ADDENDUM No. 3

**RESERVOIR AND PUMP STATION No. 2
CITY OF NORTH PLAINS, OREGON
Stantec Project No. 2002300044
September 25, 2019**

SHEET
GC-4
2002300044

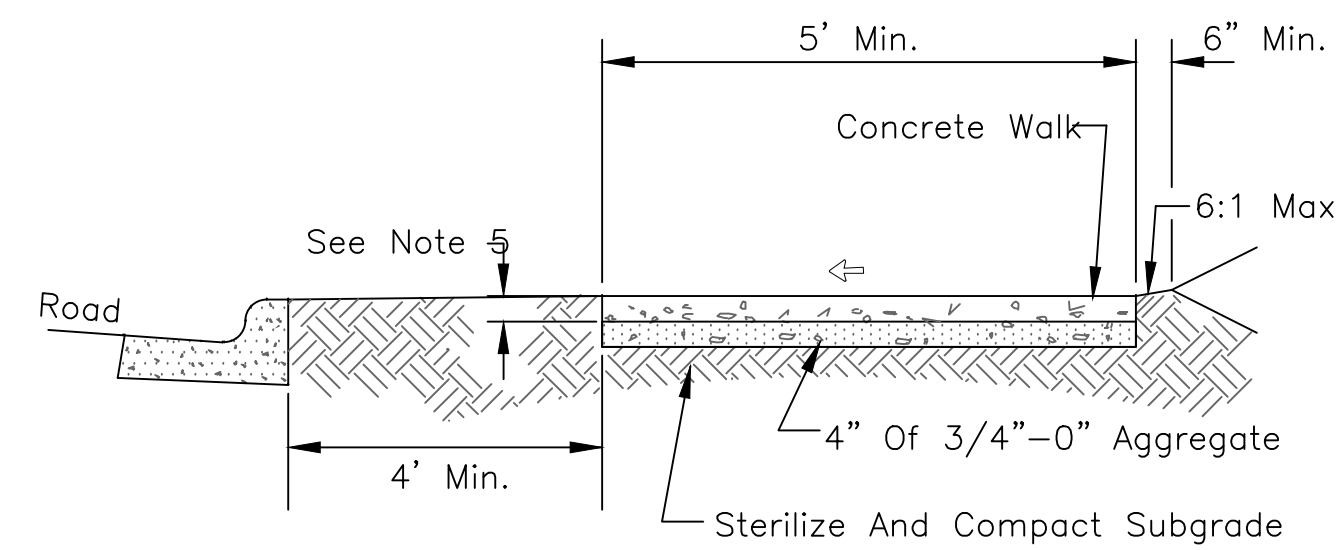
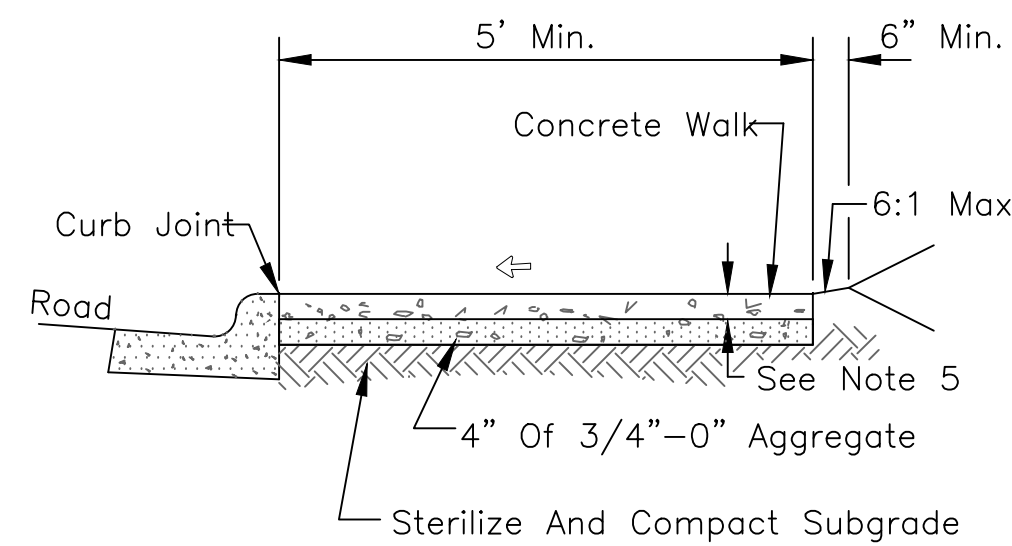
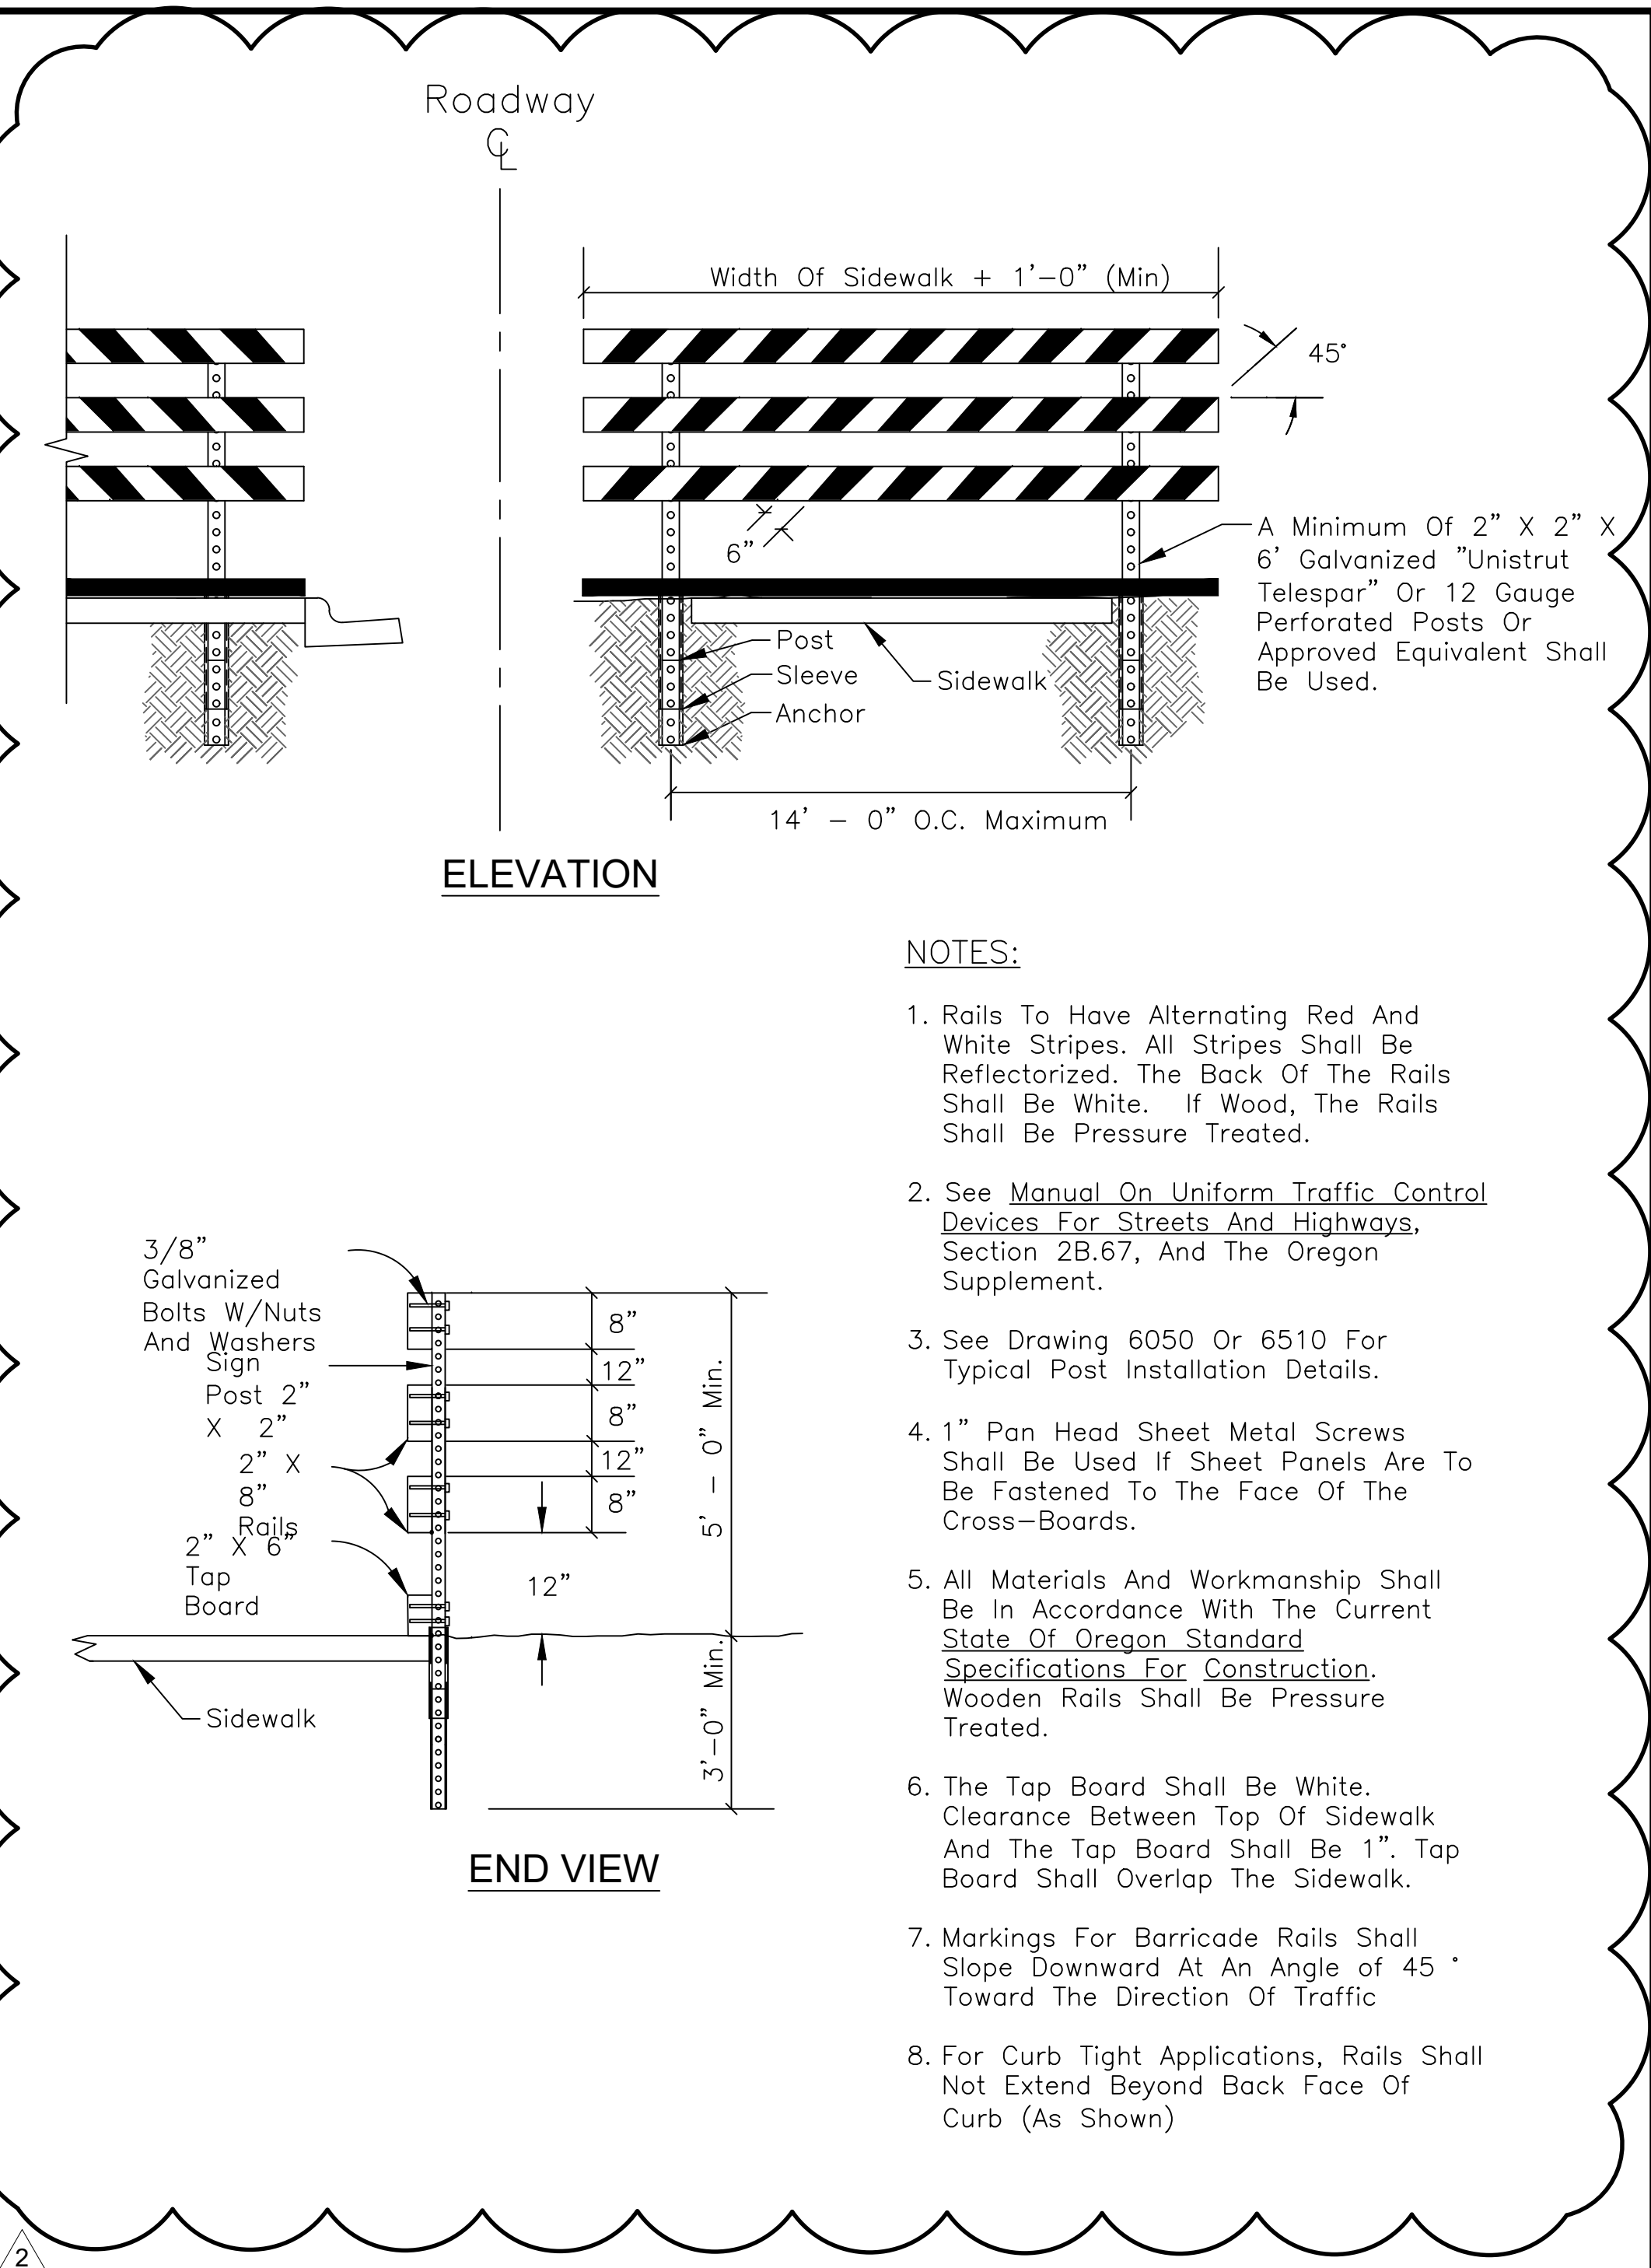
Changes to drawings are clouded and marked with a triangle indicating the revision number, date, and description.

1. See attached revisions to drawing GC-4.
